Amendments to the Drawings

Remarks

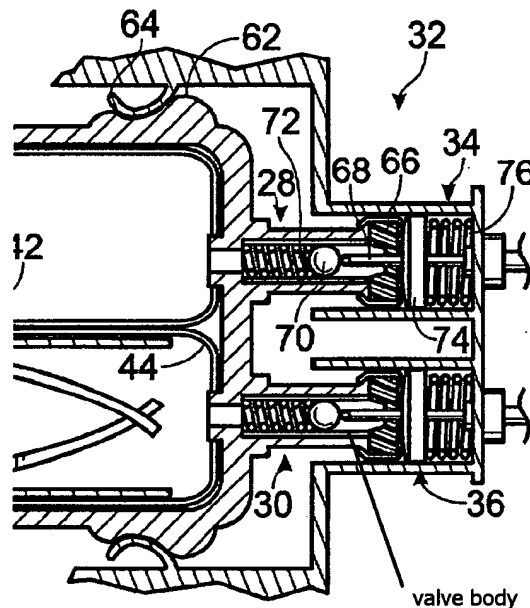
Prasad discloses a fuel supply including an outer casing 22, an inner liner 40, a valve including a valve body 30, a slidable body 70 that is biased by spring 72 to a valve seat 66, wherein the inlet pipe to the valve [is] connect[ed] to the liner as shown in figure 2, and the base valve housing is integrally connected to 22 as shown in figure 2.

Applicants respectfully disagree with the Examiner's rejection of the claims based on Prasad. Applicants will discuss the patentability of each of independent claims

1, 16 and 22 below. With reference to independent claim 1, Prasad does not disclose a valve body connected to an opening of both the liner and the casing. The valve body is the member that encloses the slidable body. As shown in Prasad's FIG. 2, the valve body, which is not labeled in Prasad but is annotated in the partial reproduction below, is disposed within an opening of outlet 28, 30 of outer casing 22 but is not in contact with any part of inner container 42, 44.

However, to move the case to allowance, claim 1 has been amended to recite that “the valve body is attached to an opening in the inner liner and to an opening in the outer casing.” As such, claim 1 is not taught or suggested by Prasad and is patentable over this reference. Claims 2-4, and 8-10 depend from and add further features to independent claim 1 and are patentable over Prasad for this reason alone. While it is not necessary to address the Examiner’s rejections of these claims at this time, Applicants reserve the right to support their patentability, when necessary.
